STATE OF MARYLAND
CRITICAL AREA COMMISSION
CHESAPEAKE AND ATLANTIC COASTAL BAYS

Re: Carrollton Manor, Lots 49-51, Seerey Property

Thank you for forwarding the final plans for the above referenced subdivision application. The applicant proposes to resubdivide two existing lots and to develop a new dwelling on each of the new lots. One of the existing lots is a 12,075 square foot lot consisting of three lots that have been merged, and the other is a 4,175 square foot grandfathered lot. The 15,209 square foot property is currently developed with a dwelling, driveway, two sheds, walkway, waterside deck, and pier. The property is designated as an Intensely Developed Area (IDA) and it is mapped as a Buffer Modification Area (BMA). I have provided my comments on the proposed project below.

FINAL DEVELOPMENT PLANS
BUFFER MITIGATION, PROP. EASEMENTS & BIT. CURB EXHIBIT

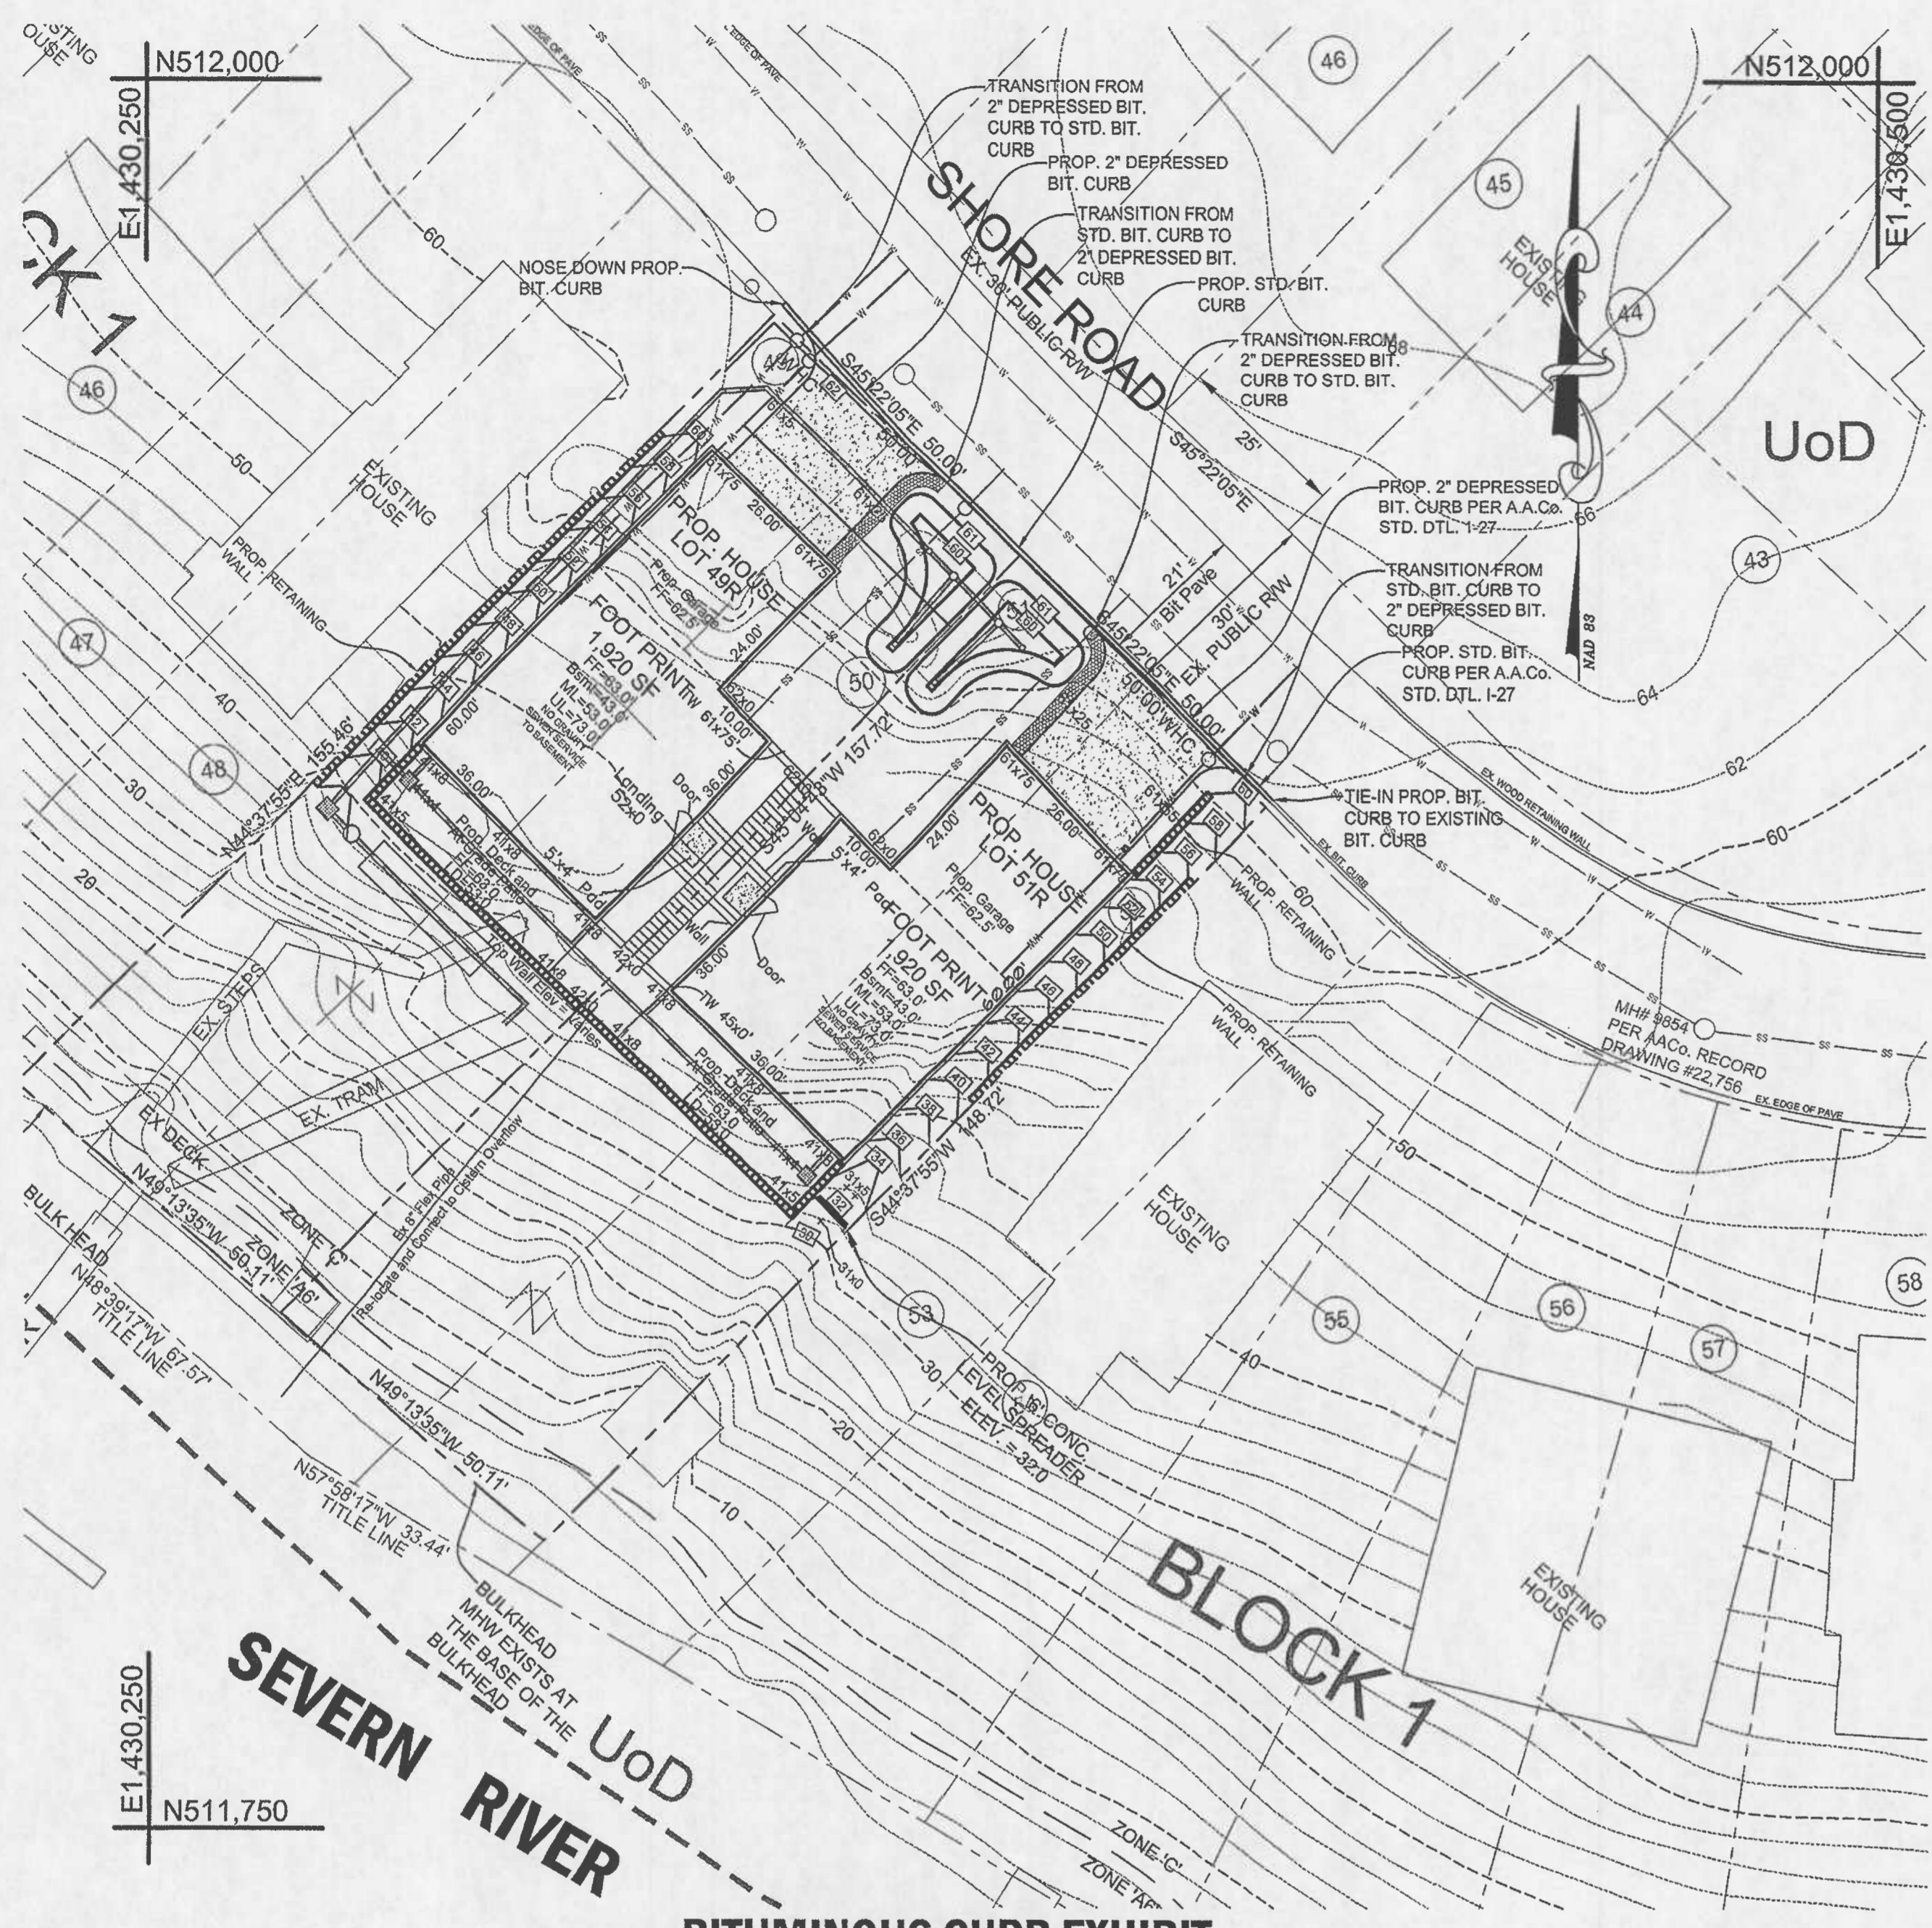
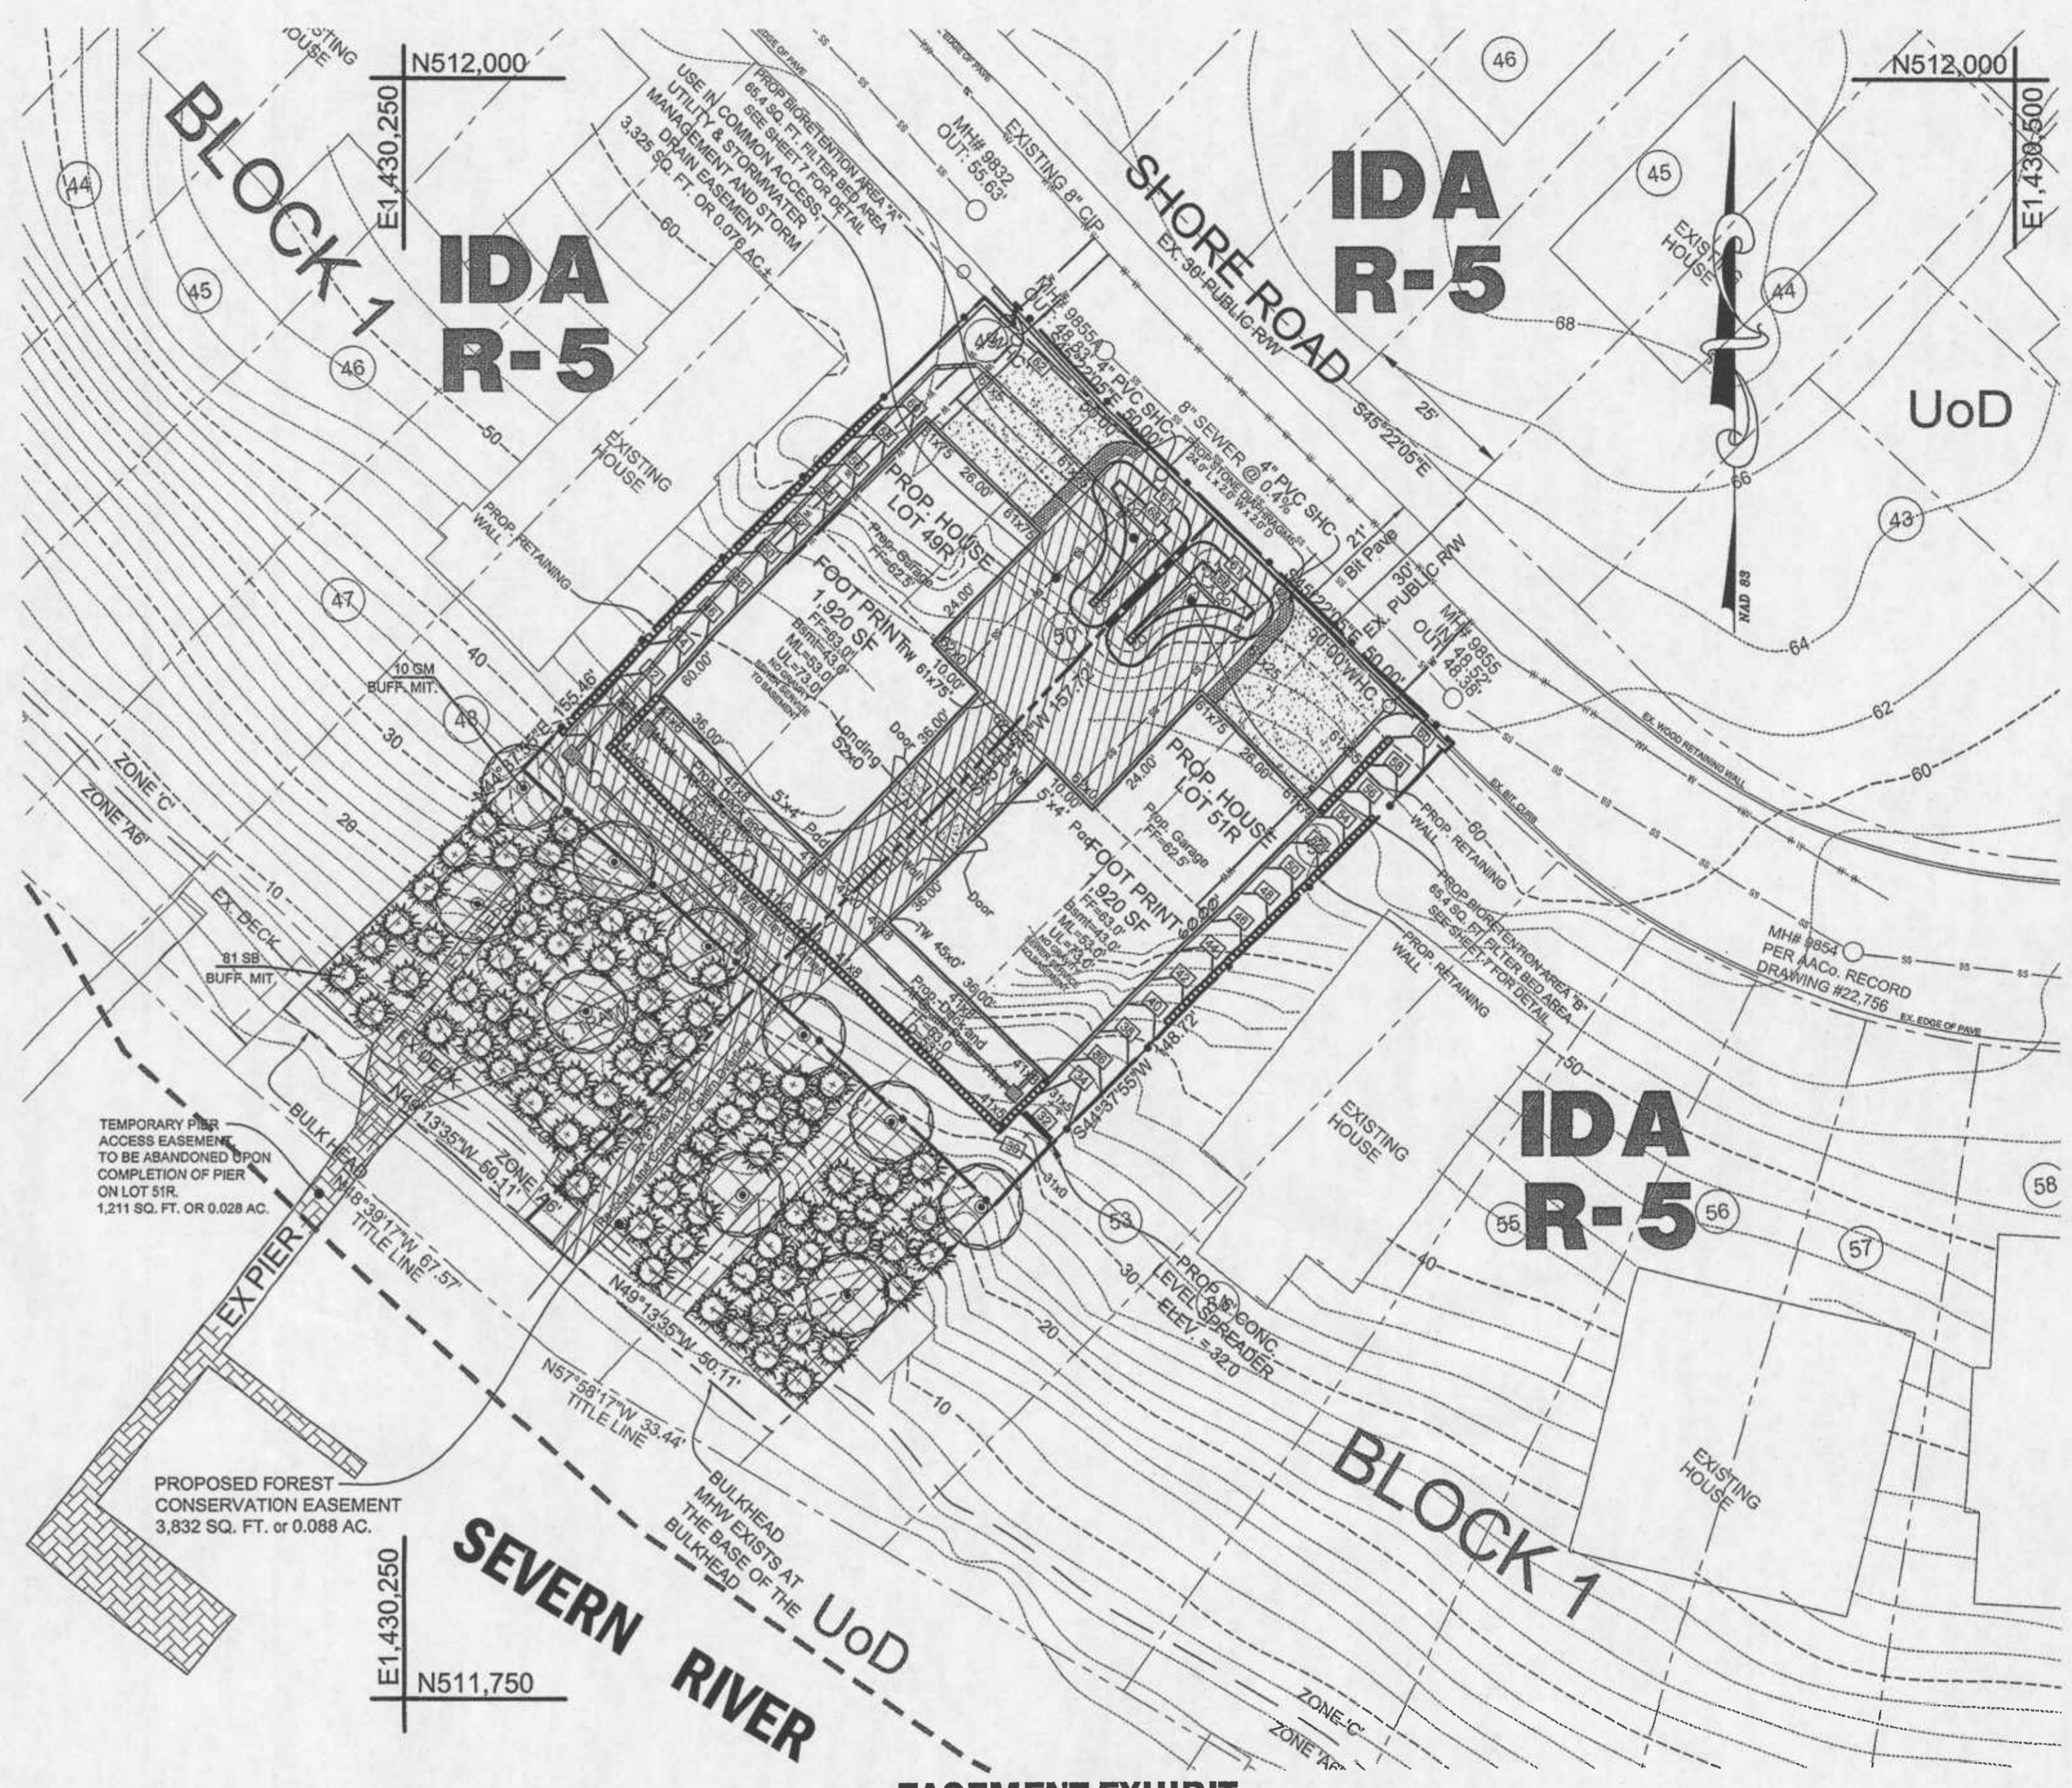
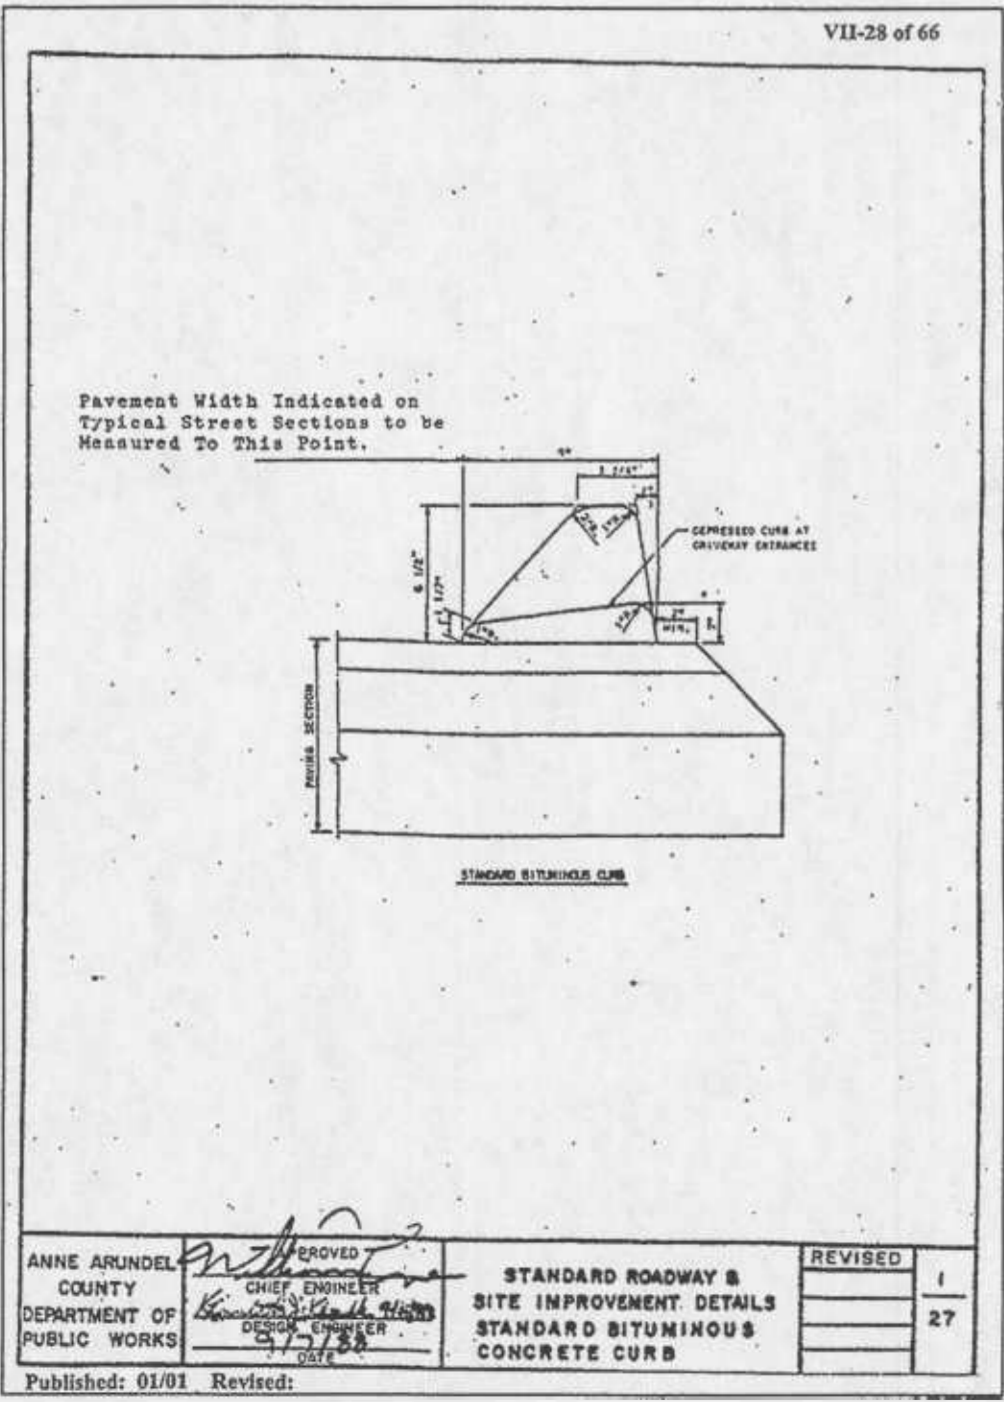
- The applicant's plans show that 2,400 square feet of reforestation plantings will be provided. While this office does not object to additional plantings being provided by the applicant, it is unclear why a reforestation requirement is referenced on the plans as typically no reforestation is required within the IDA.

- The Critical Area Residential Buffer Exemption Area policy requires that the applicant provide mitigation plantings at a ratio of 2:1 for the area of the development activity within the 100-foot Buffer, which includes the area within the limits of disturbance in the Buffer. The plans indicate that this area is 4,886 square feet, therefore 9,772 square feet of mitigation is required.

- The applicant proposes to place 4,080 square feet of the Buffer in an easement and it appears that much of this area is currently unplanted according to aerial photographs. Currently, the applicant proposes to plant 2,400 square feet of trees and shrubs in the Buffer, and it appears that more mitigation plantings can be accommodated on-site. Please have the applicant revise the planting plan showing that the 4,080 square feet within the 50-foot Buffer setback and proposed easement area will be planted such that no additional plantings can be located in that area.

- It is unclear why the applicant has calculated 1,680 square feet of Buffer mitigation credit on the plans, in addition to the 2,400 square feet of plantings that are shown within the 4,080 square foot easement area, since credit is not awarded simply for placing an area in an easement. Plantings must be provided in order to address mitigation requirements. The permanent protection of planting areas with easements or other similar instruments is a requirement in addition to providing mitigation plantings.

NOTE: OVER-PLANTING SHOWN PER C.A.C. COMMENT.
